TECHNICAL BULLETIN INDEX
Sorted by Bulletin Number
04/03/86

BULLETIN NO: II:1

PRODUCT: 26-4001/2 Model II

Figure 2

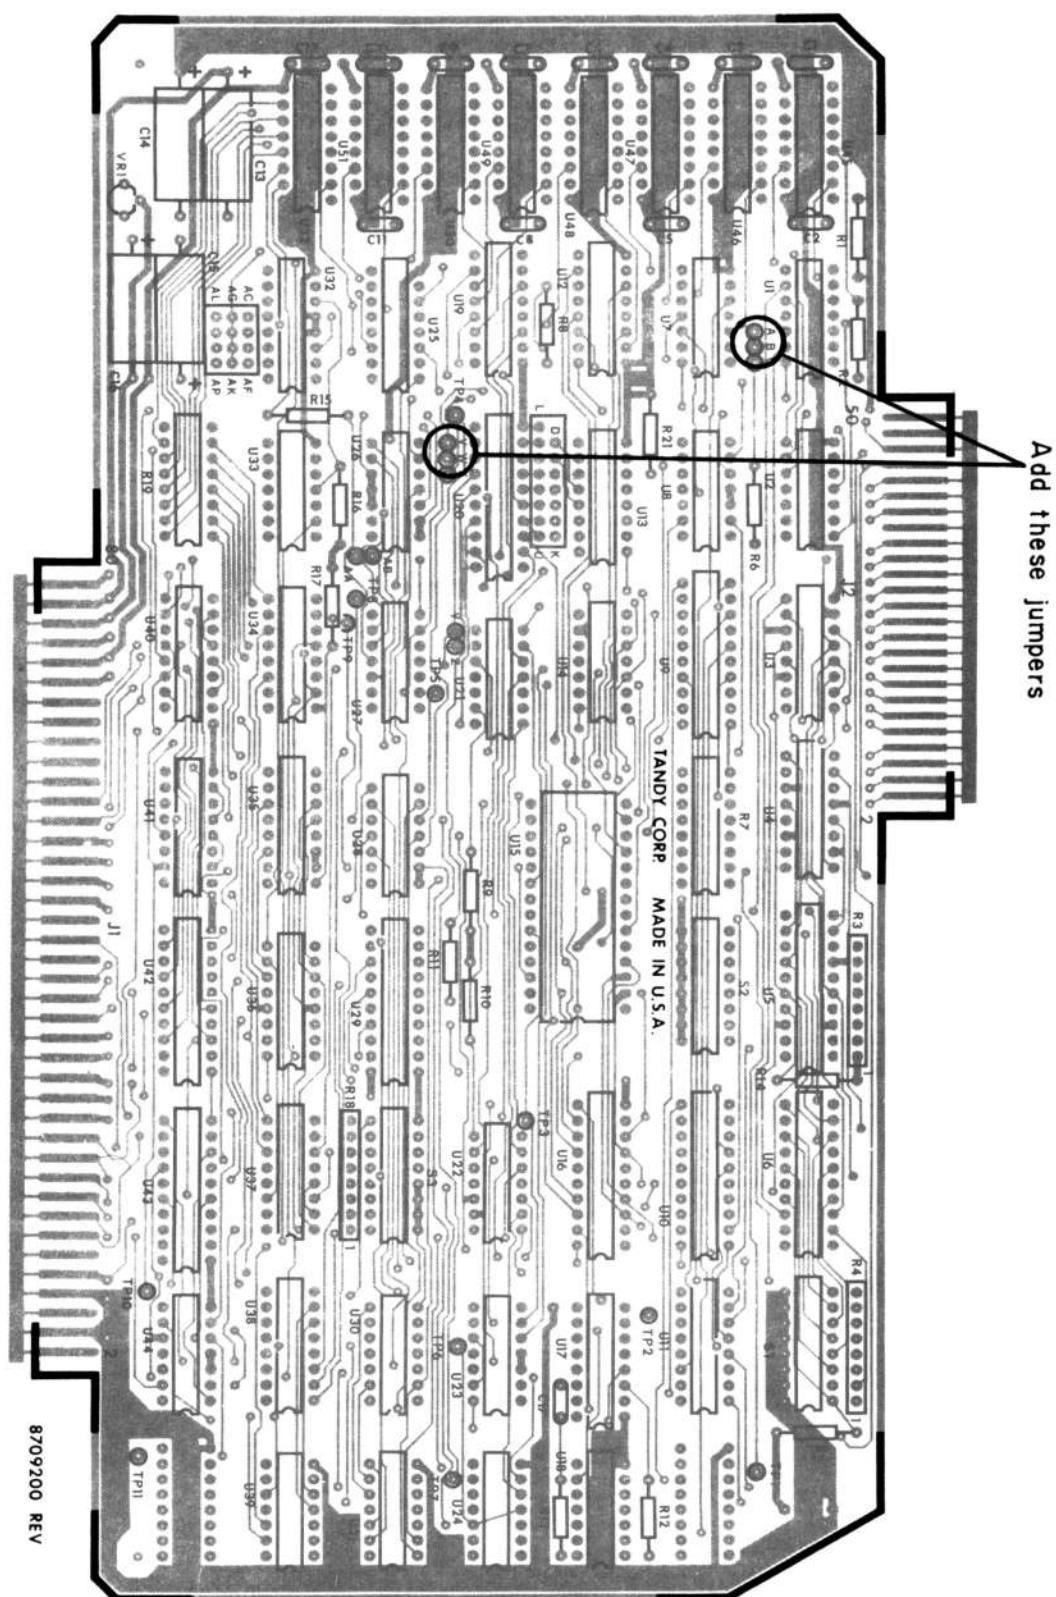
PROCEDURE: Check boards for proper jumpering and install jumpers if they are missing. For physical locations of jumpering positions refer to Figure 1 for the memory board and Figure 2 for the Interface board.

Figure 1.

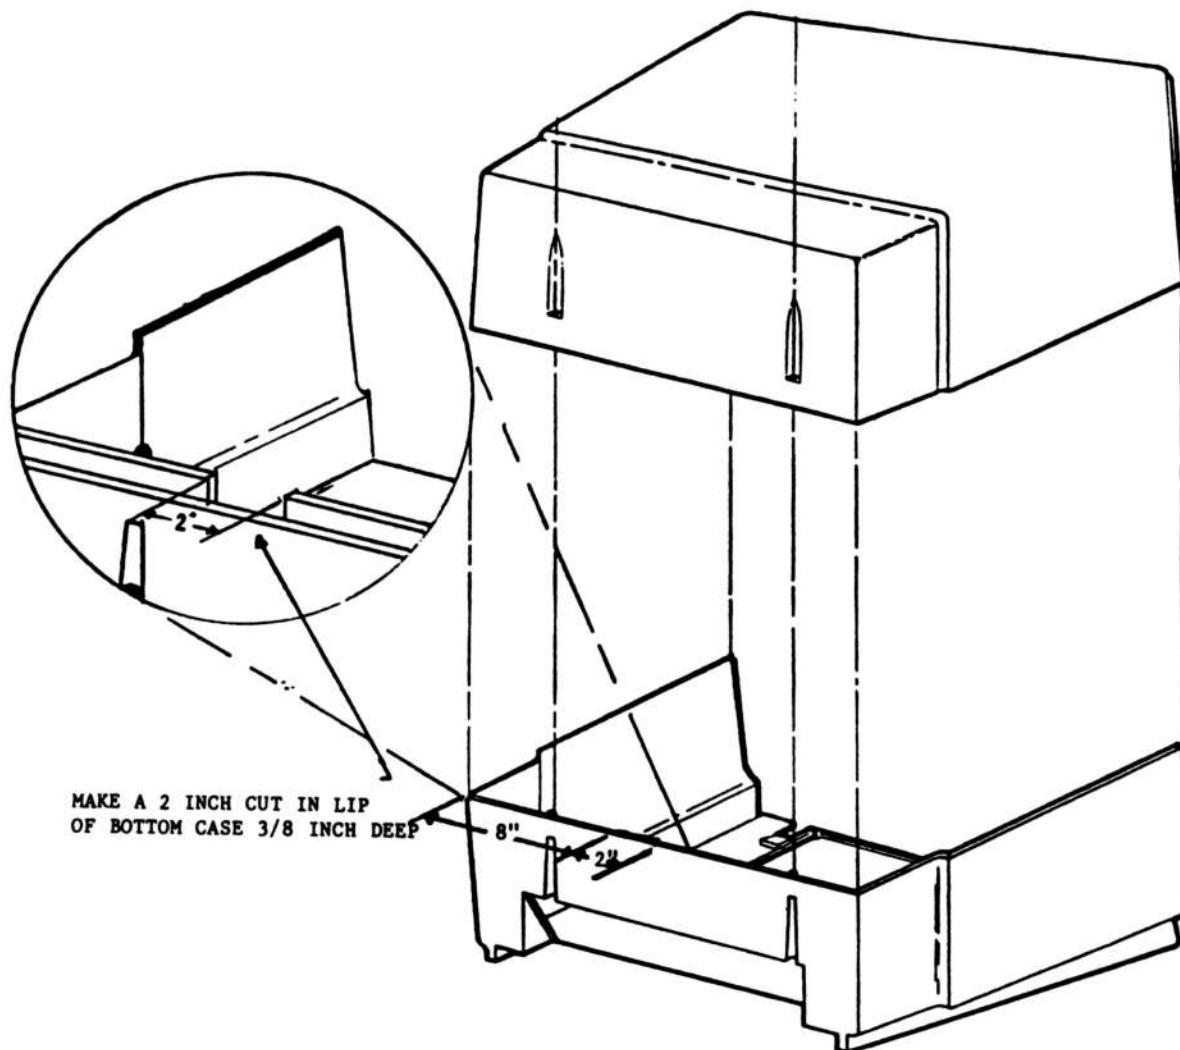
1. Remove case top to allow access to the case bottom.
2. (Refer to figure 1.) Measure 8" inches from left side (drive side) make a 3/8" inch deep cut, then measure 2" inches from first cut, and make another 3/8" inch deep cut. Cut away the two inches of plastic between the cuts. Clean the notch and make it smooth as possible.
3. Install Multi-terminal Interface board in #4 slot of card cage (count from the Z-80 CPU board to the left.) The proper slot positions should be filled as follows: (1) Z-80 CPU Board (2) FDC Board (3) Hard Drive Interface Board (4) Multi-terminal Interface Board (5) Video Board (6) 64K Memory Board (7) 68000 CPU Board (8) 16-Bit Memory Board, reading from right to left as you are facing the rear of unit looking at the card cage. If there is a board in #4 slot move all boards to the left leaving the #4 slot open for the multi-terminal board.
